**PLANNED UNIT DEVELOPMENT  
& SUBDIVISION STAFF REPORT****Date: September 5, 2013**

<b><u>NAME</u></b>	Dauphin-65 Subdivision, Resubdivision of Lots 2 & 3
<b><u>SUBDIVISION NAME</u></b>	Dauphin-65 Subdivision, Resubdivision of Lots 2 & 3
<b><u>LOCATION</u></b>	3290 Dauphin Street (Northeast corner of Dauphin Street and East I-65 Service Road North)
<b><u>CITY COUNCIL DISTRICT</u></b>	District 1
<b><u>PRESENT ZONING</u></b>	B-3, Community Business District
<b><u>AREA OF PROPERTY</u></b>	3.3± Acres
<b><u>TIME SCHEDULE</u></b>	Immediate

## DETAIL SITE PLAN

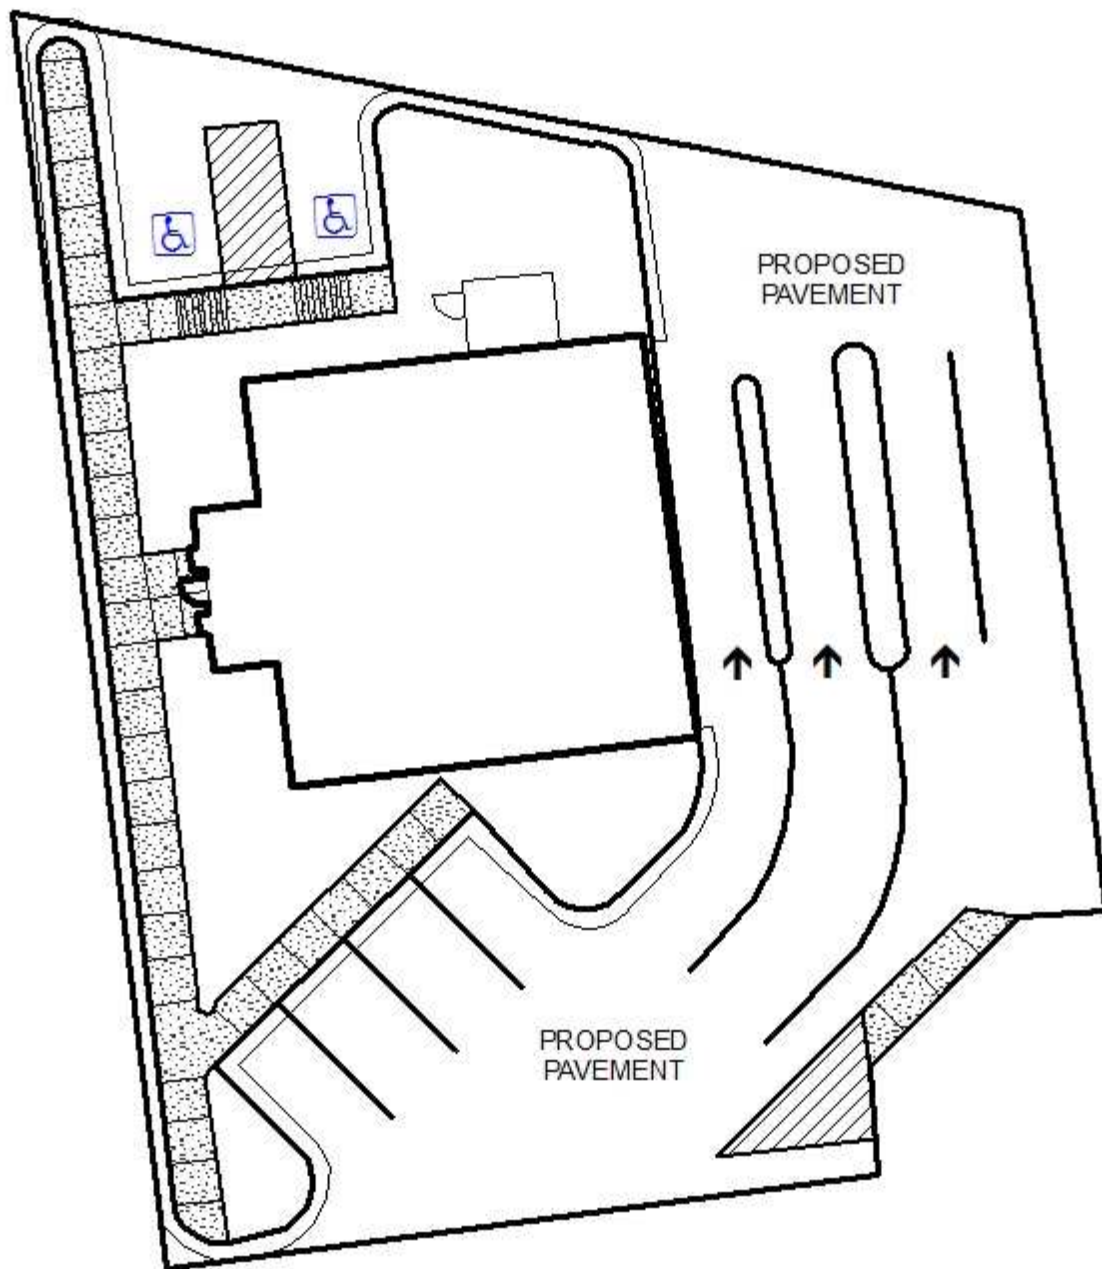
I-65 East Service Road is an ALDOT roadway. Driveway number, size, location and design to be approved by ALDOT and Traffic Engineering and conform to AASHTO standards. Please include signage on site plan provided for the Land Disturbance permit indicating one-way circulation around the drive-thru area. The change to the site layout has decreased the drive-thru queuing width from 36' to 29.2' for three lanes of

stacking. The illustrated striping does not provide a full lane width for the outermost drive-thru lane. A width of less than 12' per lane through the curve is not recommended. Exact dimensions could not be verified as the provided site plan was not printed to scale.

The proposed structure is illustrated as having three drive-thru lanes, however, queuing space is only provided for two lanes which may lead to traffic issues. The site plan should be revised to provide adequate queuing for all proposed drive-thru lanes, or the number of drive-thru lanes should be reduced to two.

A dumpster slab is illustrated on the site plan, however there is no note regarding if the dumpster will be screened in compliance with Section 64- 4.D.9. of the Zoning Ordinance. The site plan should be revised to illustrate compliant screening.

Also of note, there is no illustration or information provided regarding compliance with tree and landscaping requirements. The site plan should be revised to include this information to determine if the site will be in compliance with Section 64-4.E. of the Zoning Regulations.

*A revised site plan was submitted which states the size of the newly proposed building as 2,149 square feet and in addition, is intended to be utilized as a bank. No information was provided about the total gross square footage of the existing office. Therefore, while staff is able to determine that adequate parking is provided for the proposed bank, it is difficult to determine if adequate parking will be provided for all uses on the site to meet the minimum requirements of Section 64-6.6. of the Zoning Ordinance.*

*A note was placed on the site plan stating that the bank will not use a dumpster; however there is an existing "dumpster slab" on the Northeast portion of the lot. The site plan should be revised to illustrate screening in compliance with Section 64- 4.D.9. of the Zoning Ordinance.*

*The revised site plan does have a note indicating the amount of landscaped area and trees for the portion of the site the bank will occupy, however, the locations of the trees are not illustrated, and landscaping information should be provided for the entire site to ensure compliance with Section 64-4.E. of the Zoning Regulations.*

- 1) revision of the site plan to provide the total gross square feet of both structures;
- 2) revision of the plat to provide the use of the proposed building;
- 3) revision of the site plan to provide adequate queuing for three drive-thru lanes, or revision of the site plan to only provide two drive-thru lanes;

- 4) revision of the site plan to illustrate dumpster screening compliant with Section 64-4.D.9. of the Zoning Ordinance; and
- 5) revision of the site plan to illustrate compliance with tree and landscaping requirements, including information about landscape area and number of trees.

*The site plan was revised to illustrate queuing spaces of appropriate width to accommodate three drive-thru lanes.*

- 1) revision of the site plan to provide the total gross square feet of both structures;*
- 2) revision of the site plan to illustrate dumpster screening compliant with Section 64-4.D.9. of the Zoning Ordinance; and*
- 3) revision of the site plan to illustrate compliance with tree and landscaping requirements, including information about landscape area and number and species of trees.*
